Transport
for NSW

New Intercity Fleet Maintenance Facility Project

Submissions Report

New Intercity Fleet Maintenance Facility Project
Figure 4.1
 Areas of vegetation proposed to be retained

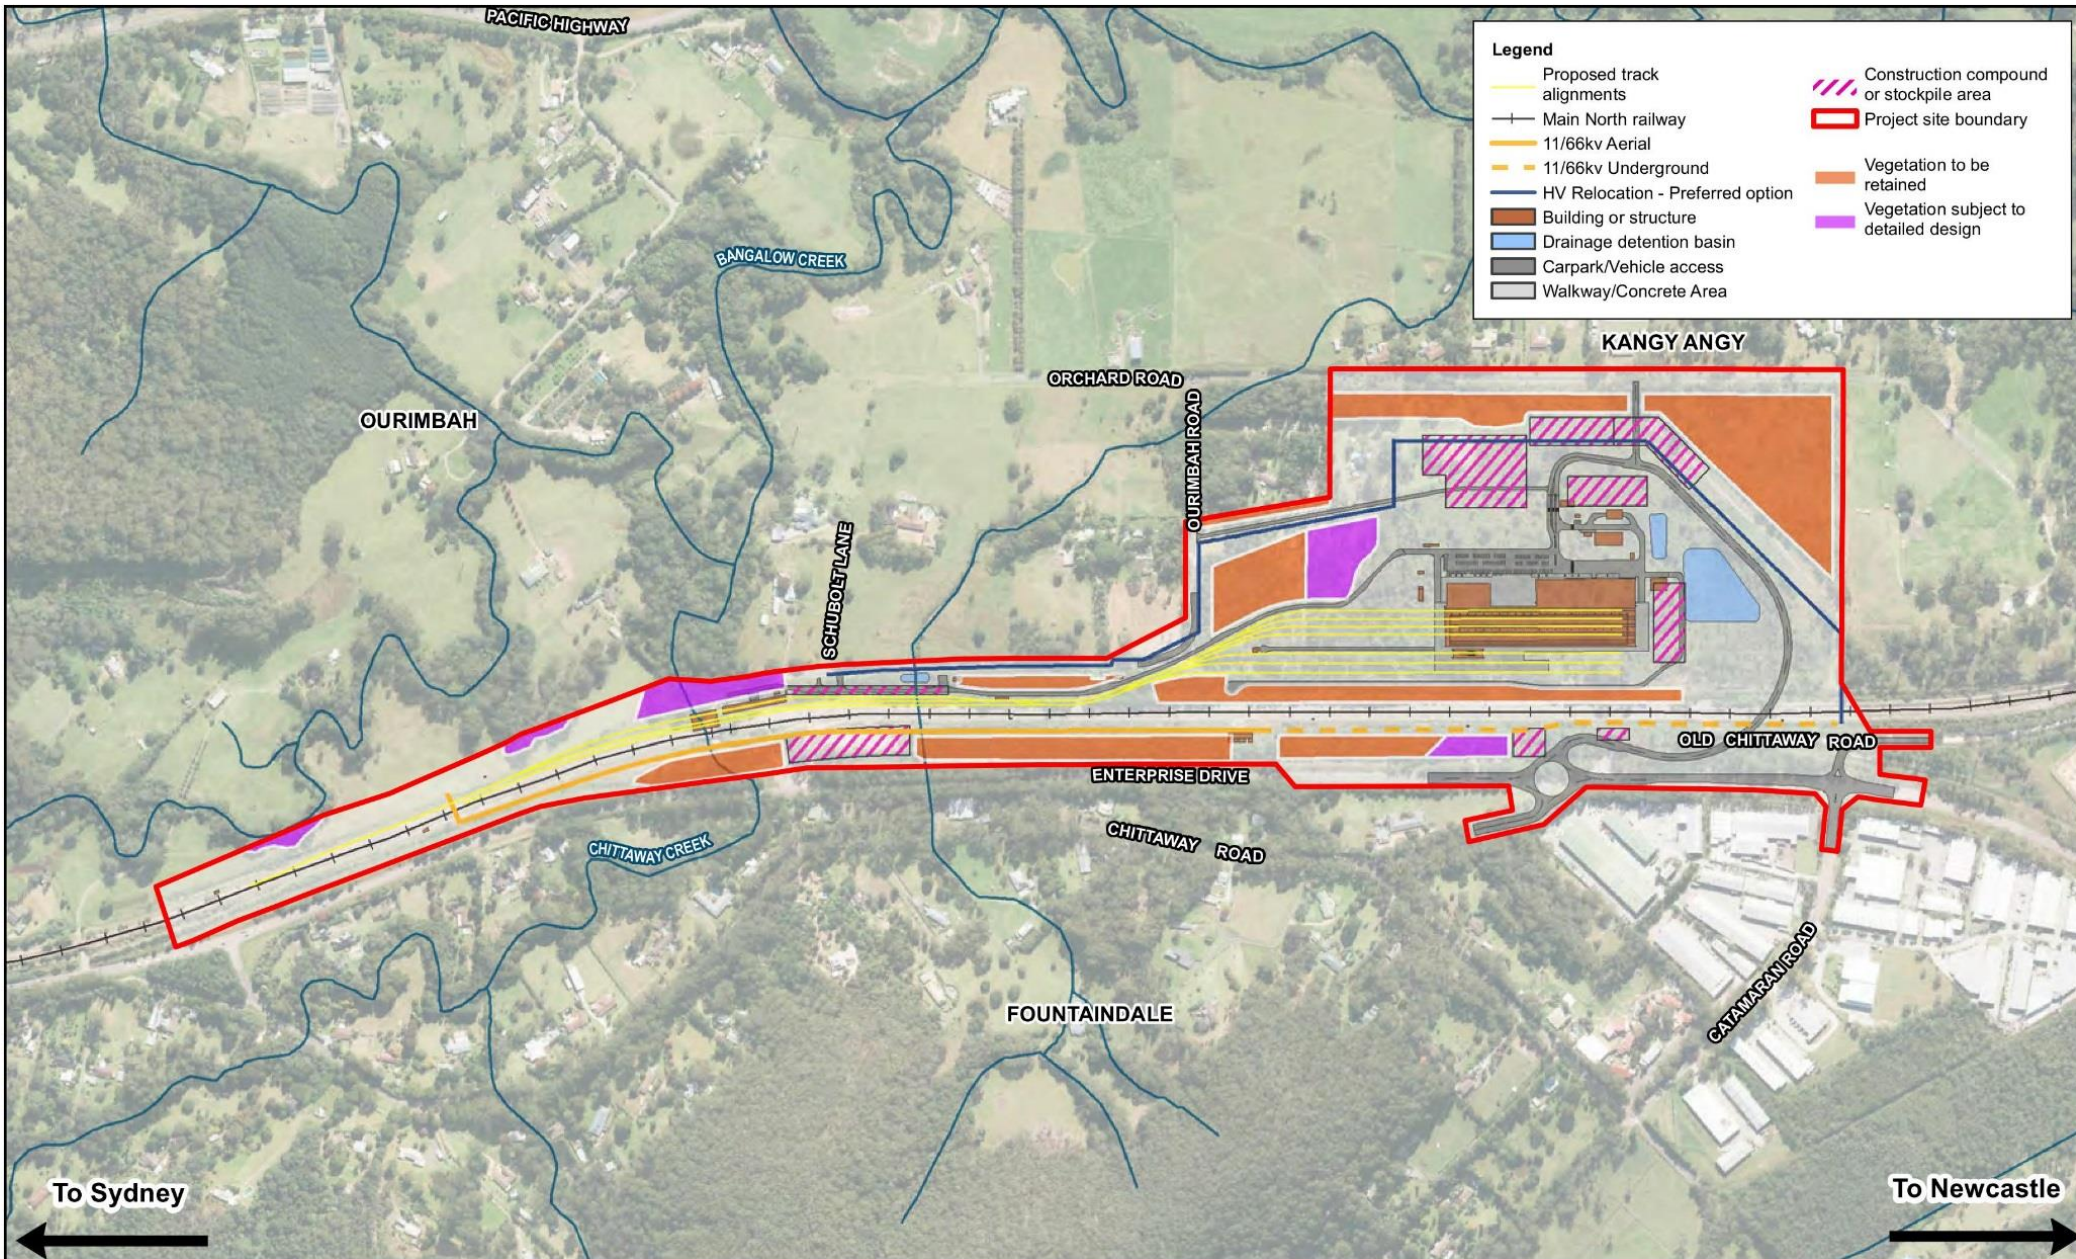
Response

The revised areas of vegetation to be retained are shown in Figure 4.1 and the change in area is summarised in Table 4.1.

As can be seen from Table 4.1, refinement of the Project following public display of the REF has identified an additional 0.71 hectares of vegetation which is proposed to be retained (subject to detailed design of the Maintenance Facility) across the Project site. Ongoing detailed design of the Project would also seek to further refine the Project design and overall footprint in order to reduce the overall potential for impacts to vegetation within the Project site.
